AMENDMENTS TO THE DRAWINGS

REMARKS

At the outset, the Examiner is thanked for the thorough review and consideration of the pending application. The Office Action dated July 3, 2006 has been received and its contents carefully reviewed.

FIG. 5

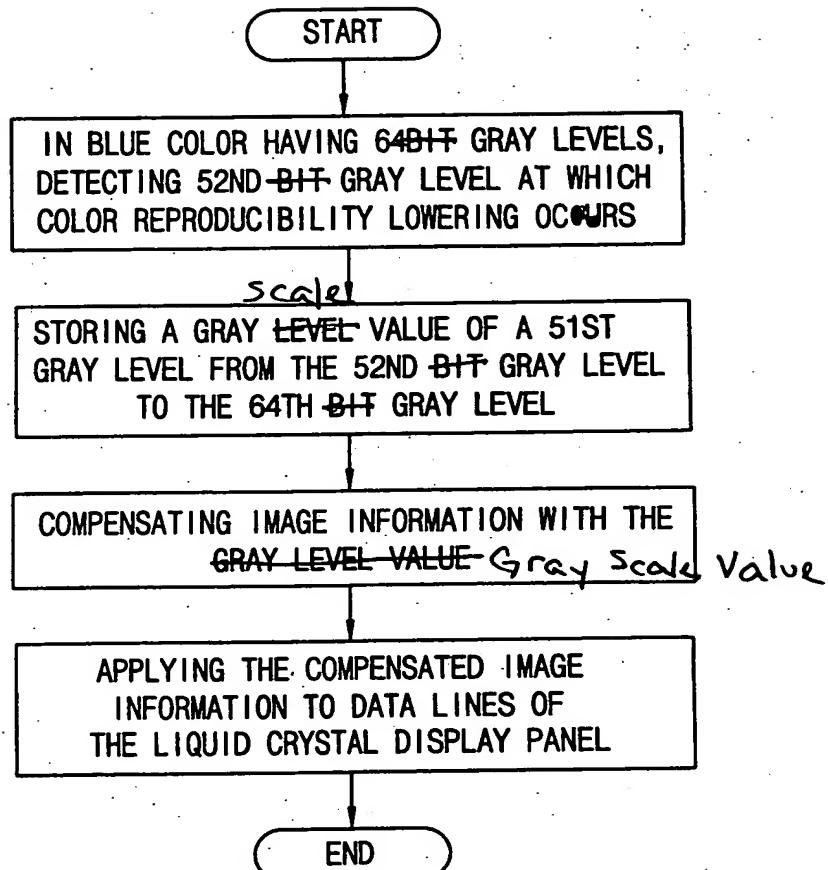
The attached sheets of drawings include changes to Figs 5, 6, and 8. These sheets, which include Figs. 5, 6, and 8, replace the original sheets including Figs. 5, 6, and 8. The following changes have been made to Fig. 5, 6, and 8 to remove clarify the description of gray scale levels.

The Examiner objects to FIGs. 5, 6, and 8 as containing informalities. In particular, the Examiner objects to the use of the terminology "64-bit gray scale." With this response, Applicants have provided replacement sheets containing amended FIGs. 5, 6, and 8 which do not contain use the term "64-bit gray scale," and respectfully request that the objections to the drawings be withdrawn.
